DESCRIPTIVE REPORT

Type of Survey Hydrographic
Field No. RA-10-12-98
Registry No. H-10852

State Alaska
General Locality Southwest Prince William Sound
Sublocality Drier Bay and Vicinity

Descriptive Report to Accompany Hydrographic Survey H-10852

CHART 16704 (DRIER BAY)
 12TH EDITION, MAY 16, 1998
 SCALE 1:20,000

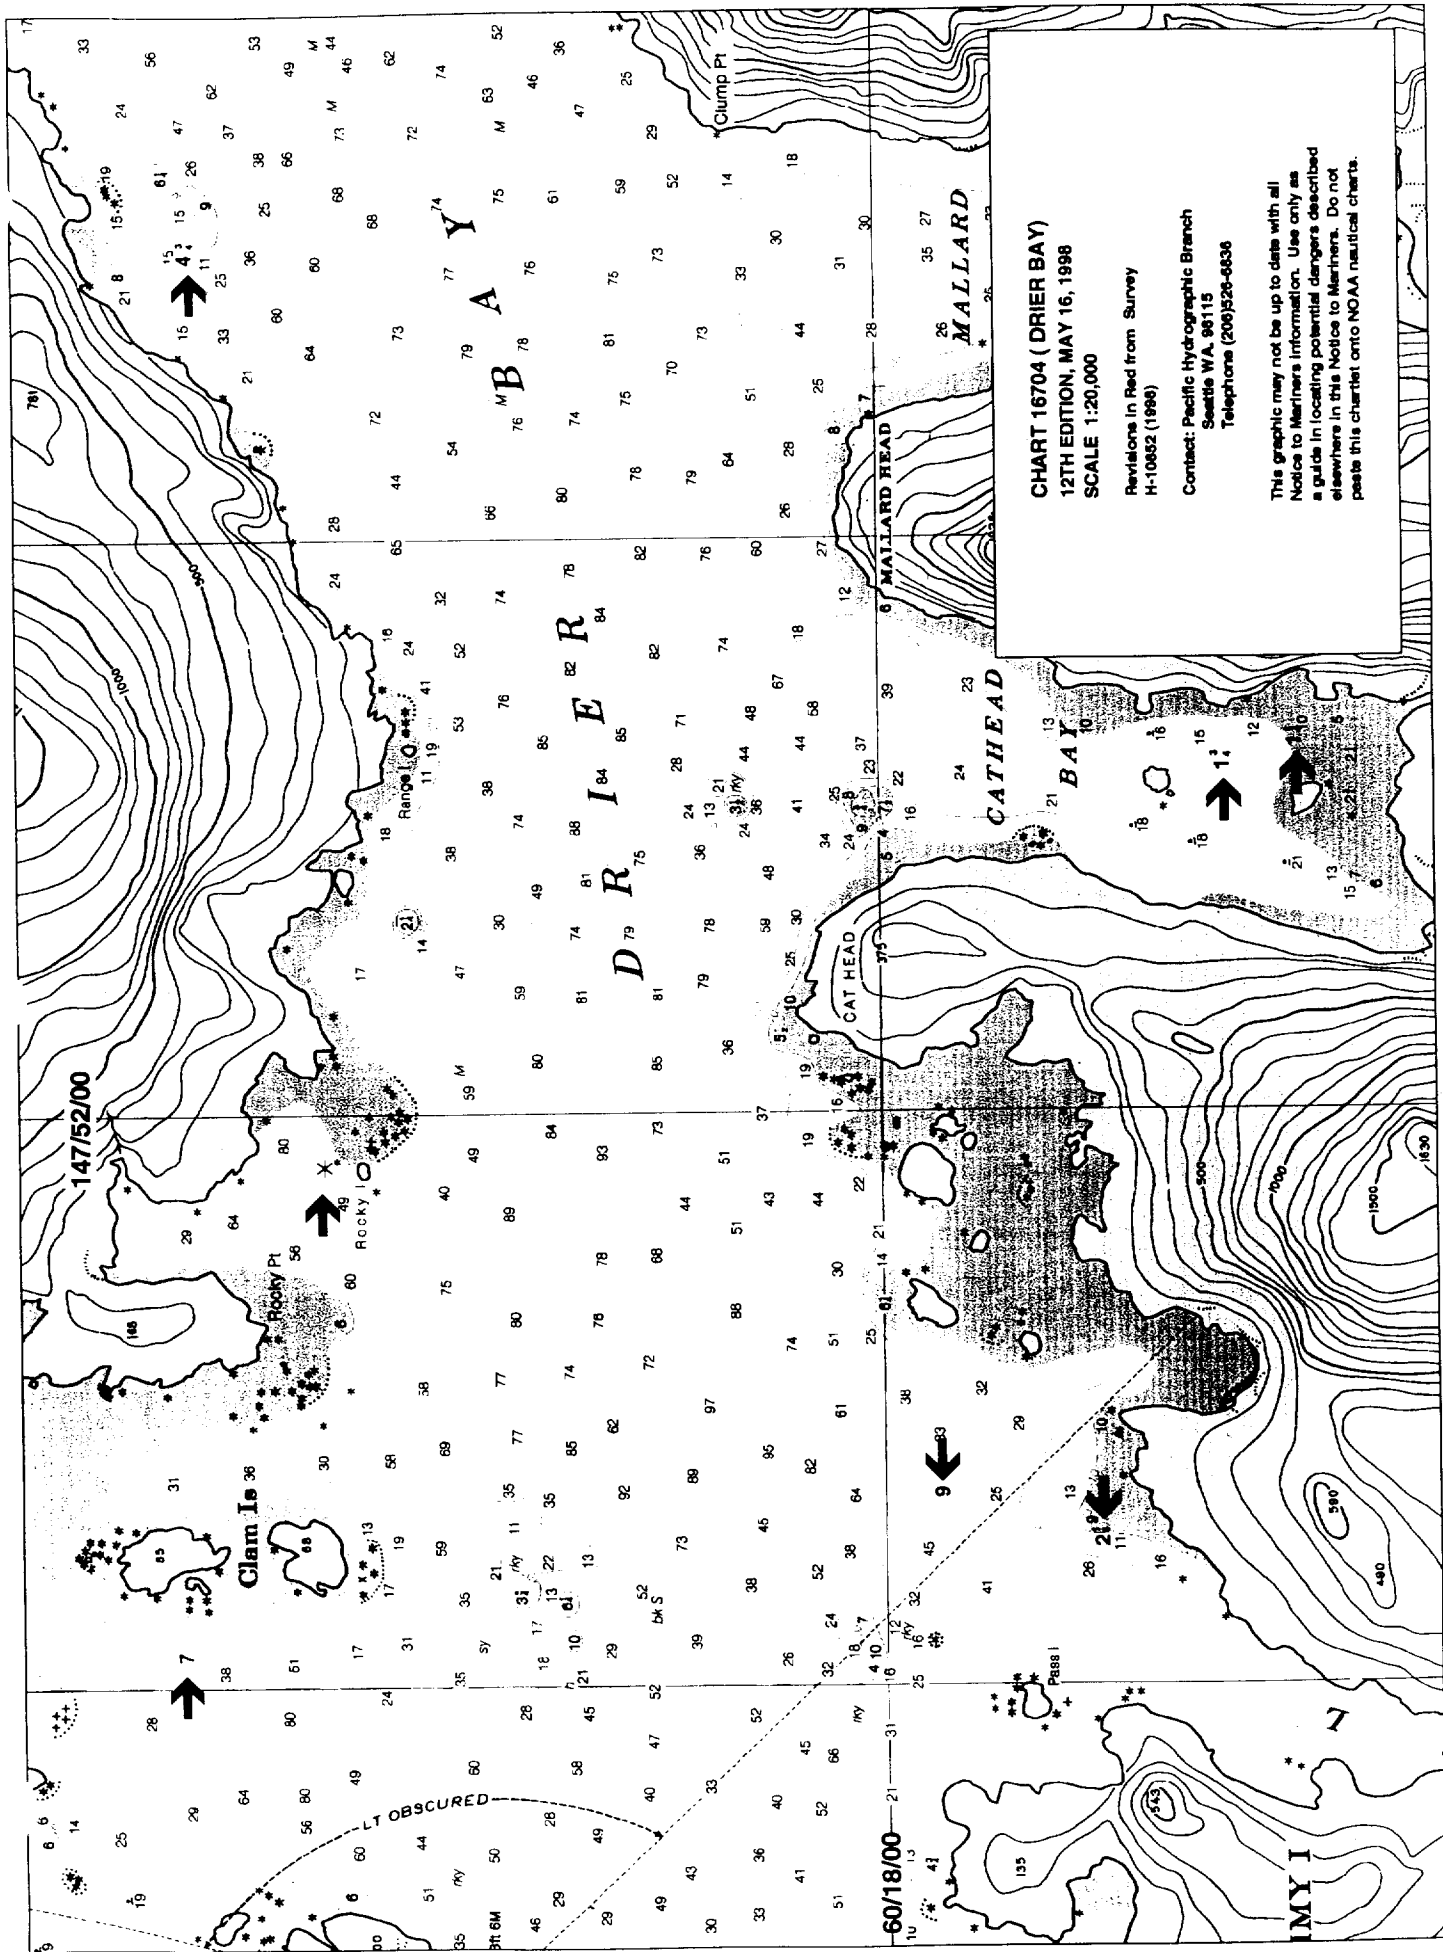
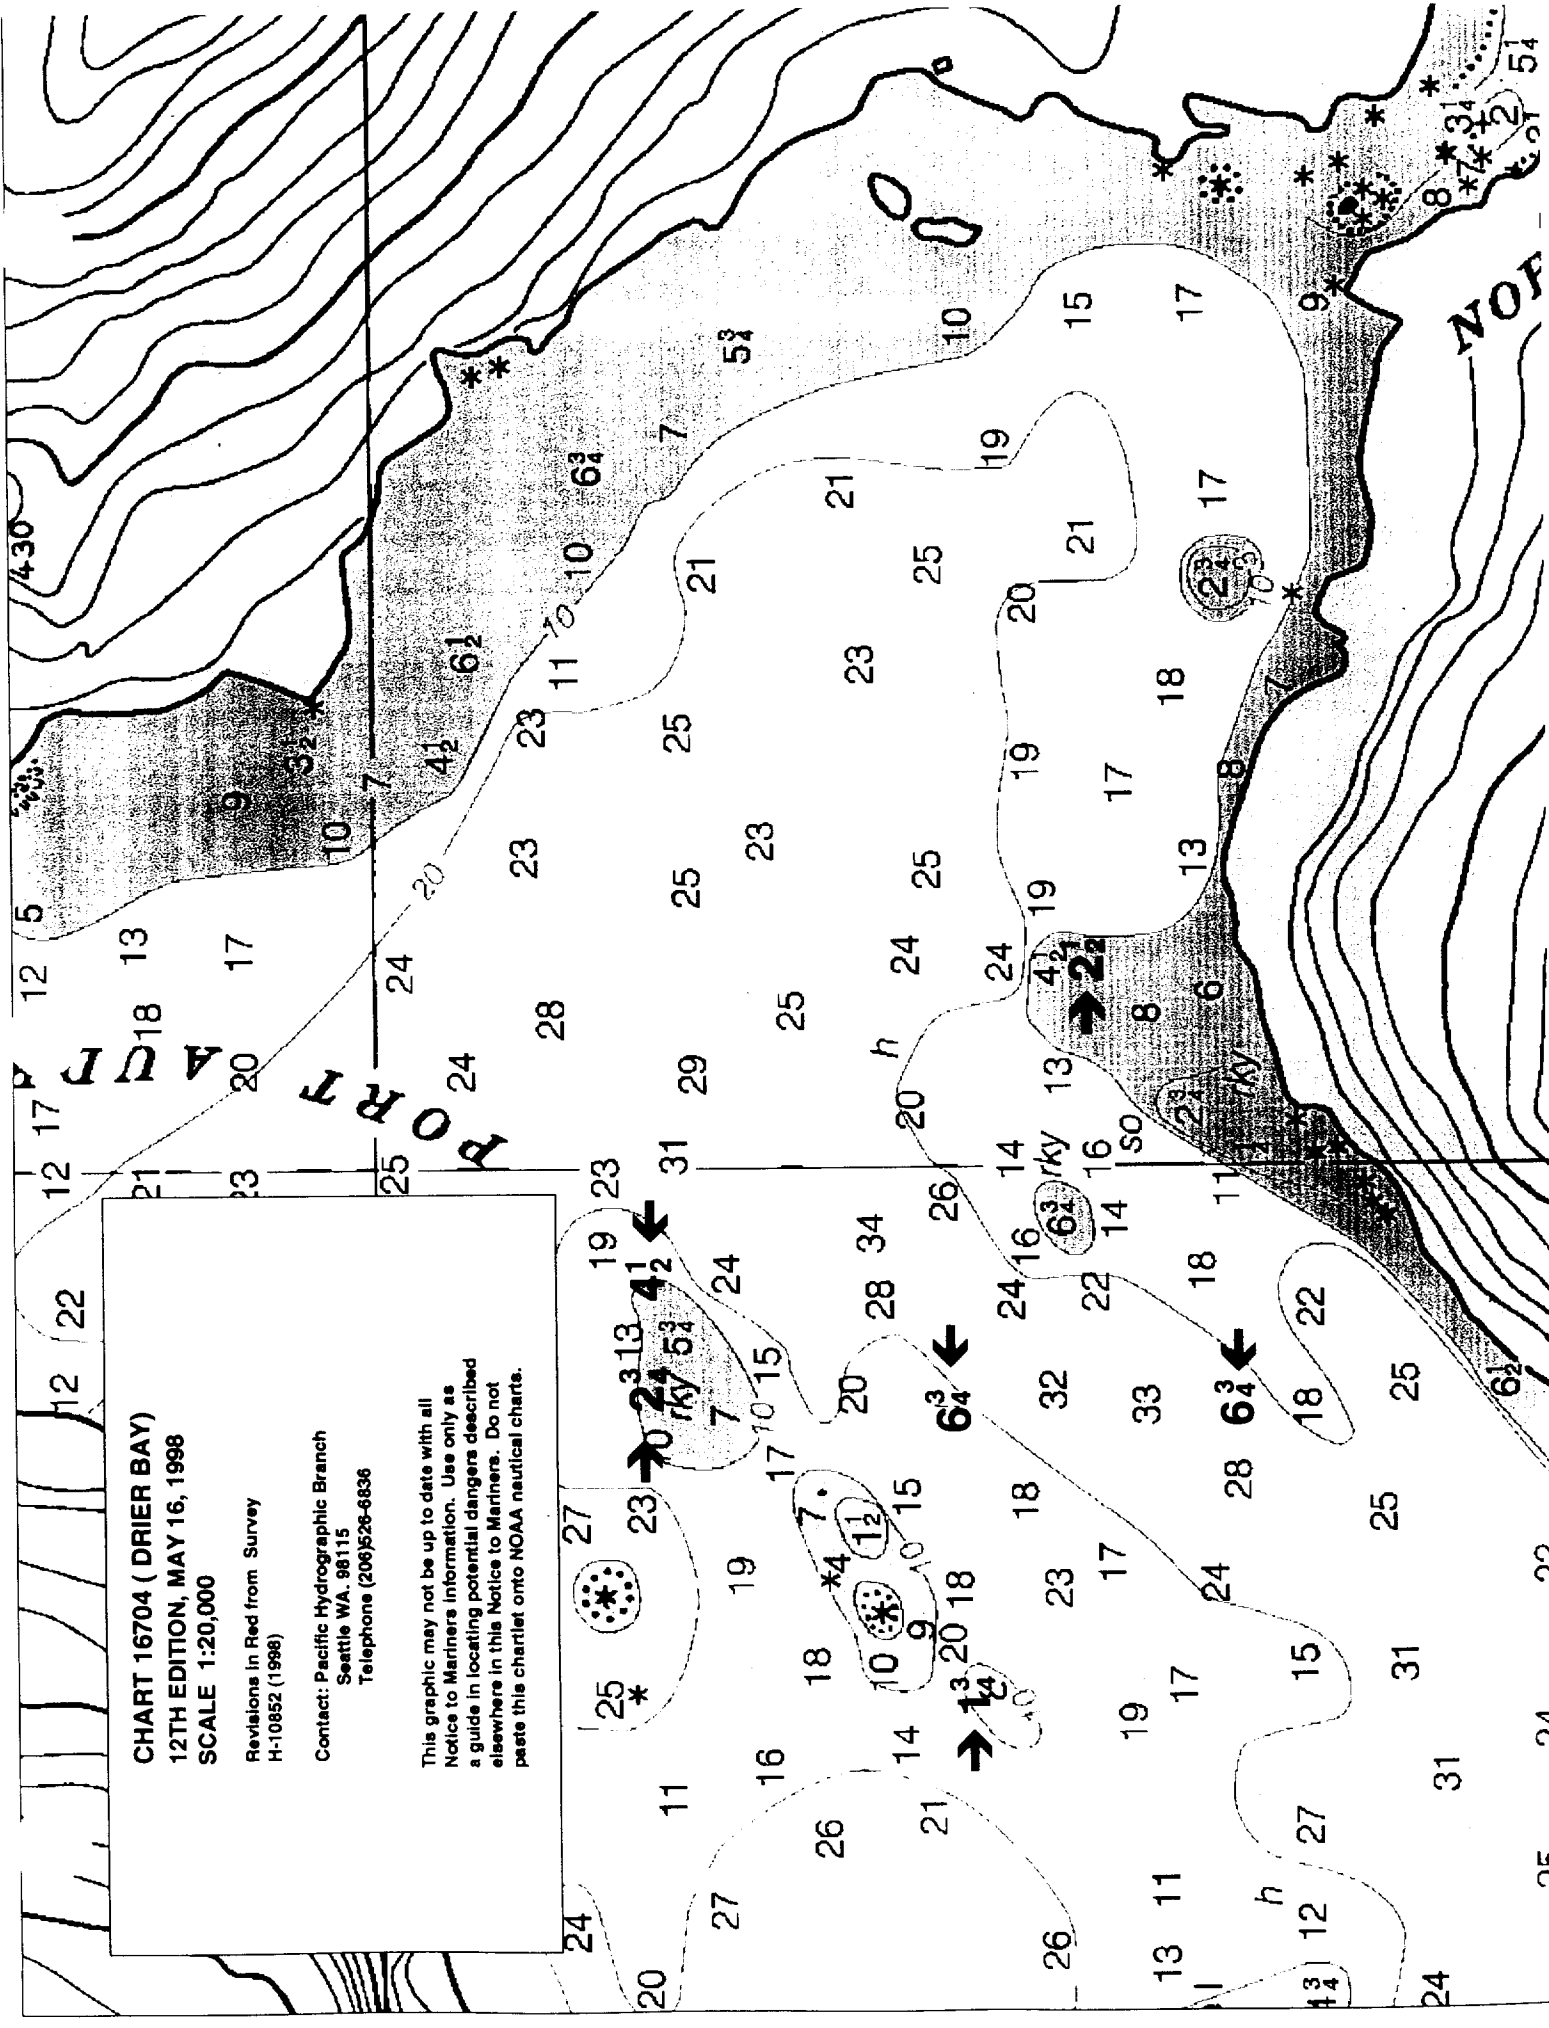
Revisions in Red from Survey
 H-10852 (1998)
